# Wisconsin Department of Transportation

**Proposal #17: 1500-37-76, WISC 2019 743**  
**Waldo Blvd, City of Manitowoc**  
**Fleetwood Drive – 14<sup>th</sup> Street**  
**USH 10**  
**Manitowoc County**

This is Addendum No. 01, which provides for the following:

**ADDENDUM NO. 01**  
**1500-37-76, 1500-37-77, 1500-47-71**  
**December 4, 2019**

TRAFFIC SIGNAL PLAN-18TH ST.  
 COUNTY: MANITOWOC  
 HWY: USH 10  
 PROJECT NO: 1500-37-76  
 SHEET 125  
 E

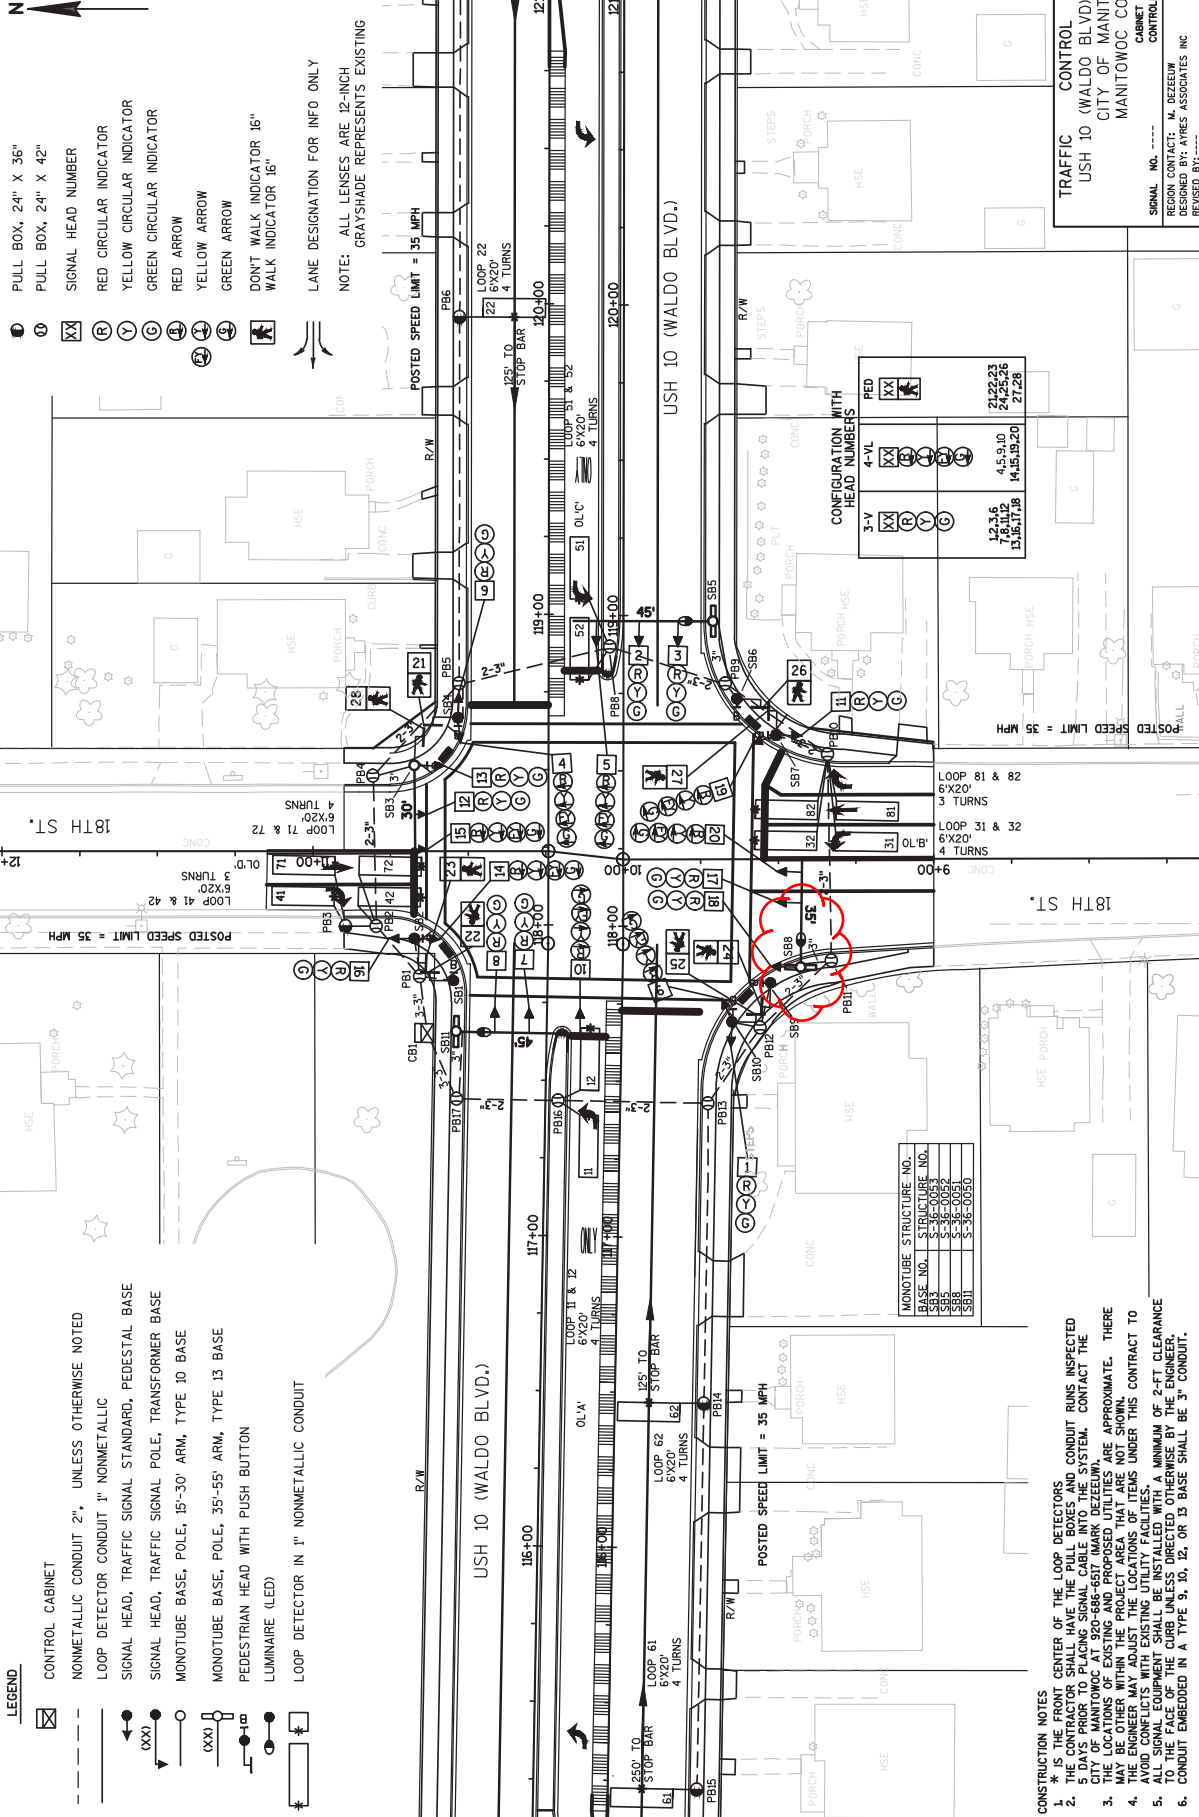
<b>Revised Plan Sheets</b>	
Plan Sheet	Plan Sheet Title (brief description of changes to sheet)
125	Traffic Signals (Added Luminaire to SB8 with WisDOT provided pole)
151	Detour Signing (Modified project location and covering signs)
220-221	Miscellaneous Quantities (Updated signs, PCMS, and covering signs)
225	Miscellaneous Quantities (Updated signs, PCMS, and covering signs)
237	Miscellaneous Quantities (Removed Pole Type 12 and 35' monotube arm. Added Install Type 13 Pole with 35' arm for SB8. Added Luminaire for SB8)
239	Miscellaneous Quantities (Updated lighting wire quantities for new luminaire for SB8)
245	Miscellaneous Quantities (Updated Furnish & Relay Sanitary Sewer Pipe 12")
274	Sanitary Sewer and Water Main (Sanitary line work was completed in fall of 2019 that reduced mount to be installed between manholes 22 & 23)
275	Sanitary Sewer and Water Main (Sanitary line work was completed in fall of 2019 that reduced mount to be installed between manholes 22 & 23)

Addendum No. 01  
 ID 1500-37-77  
 Revised Sheet 274  
 December 4, 2019

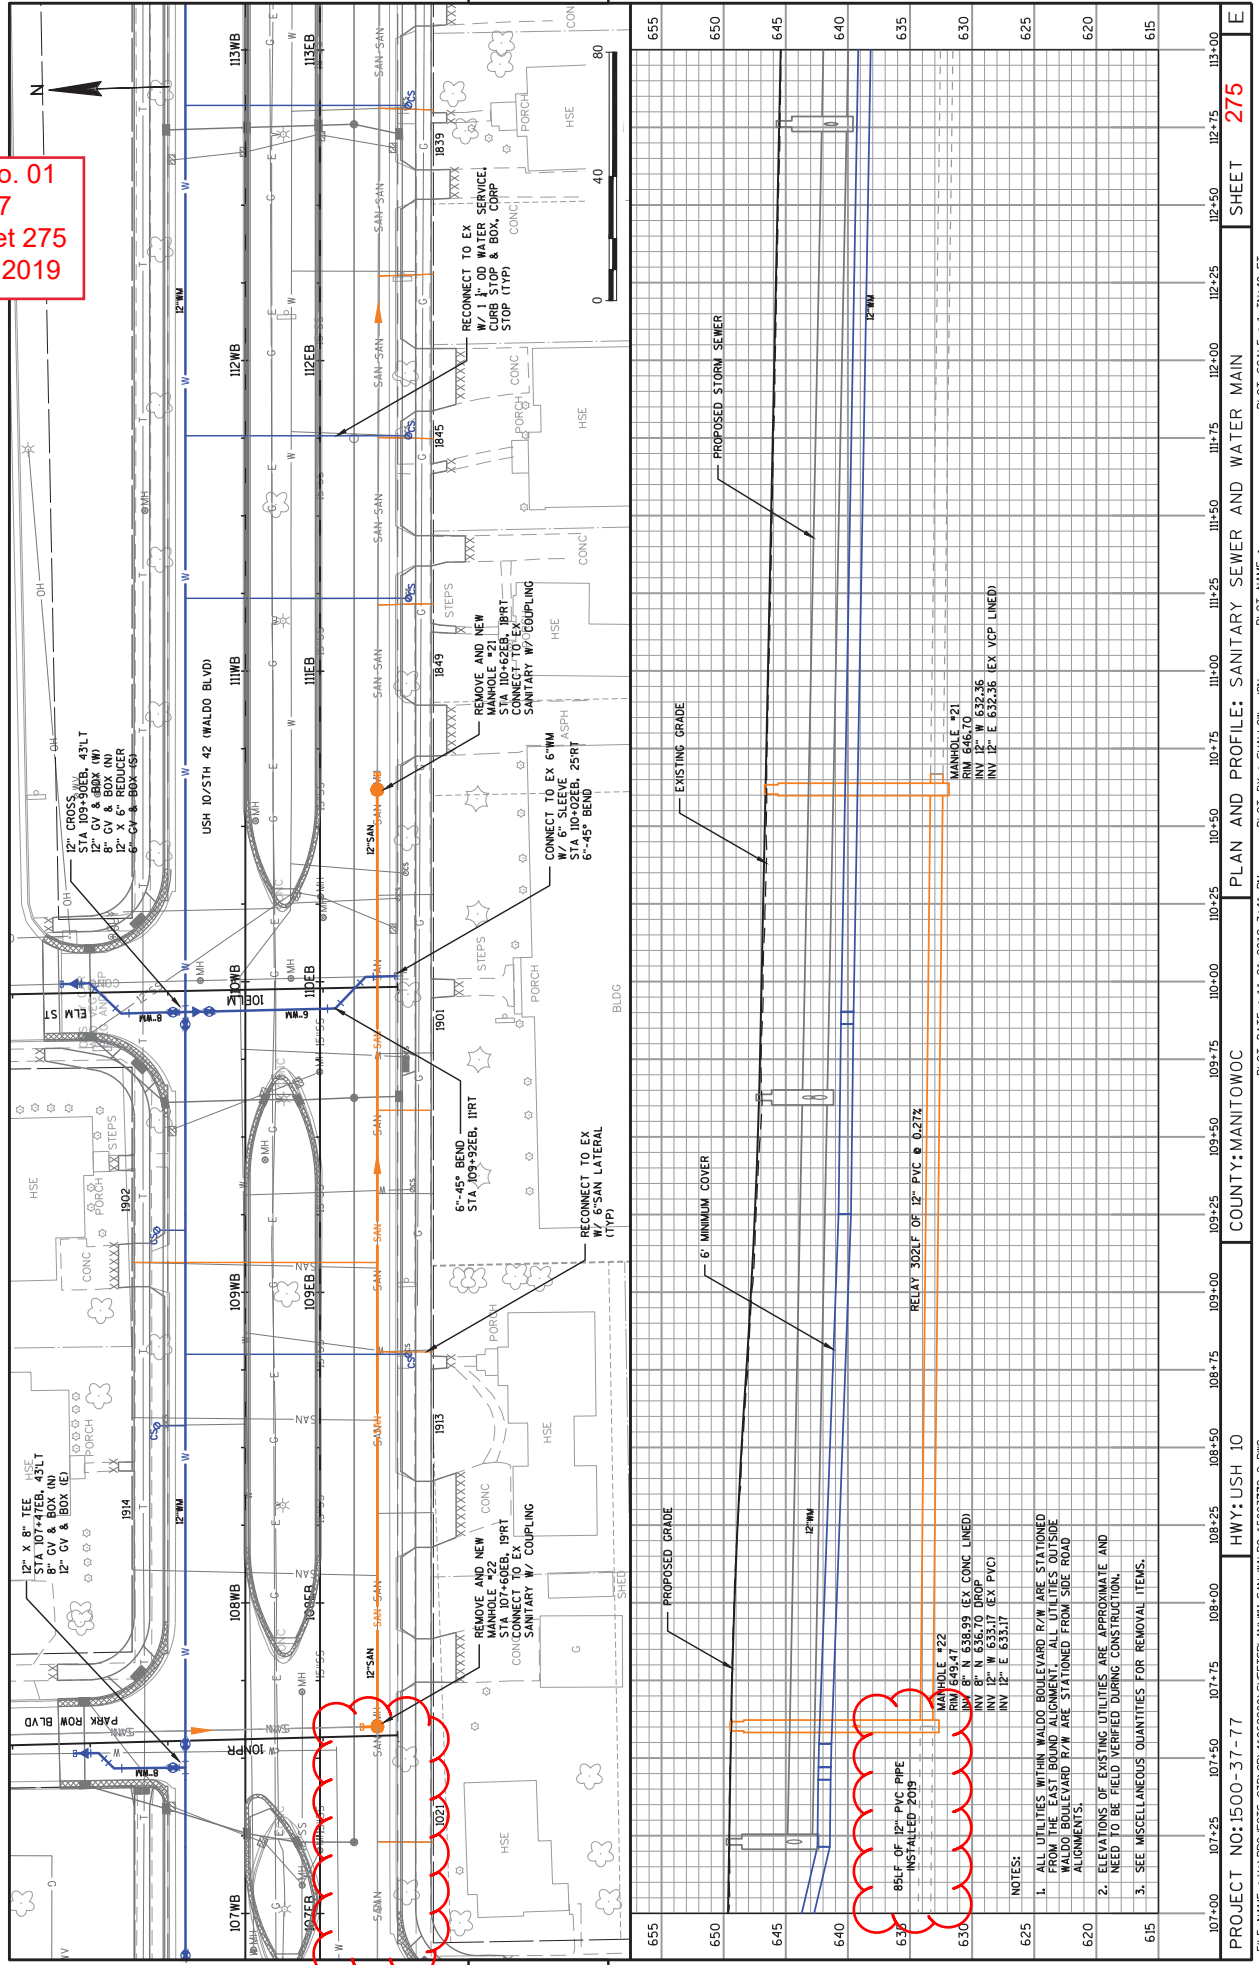
RELAY OF 12" PVC  
 25LF @ -0.27%
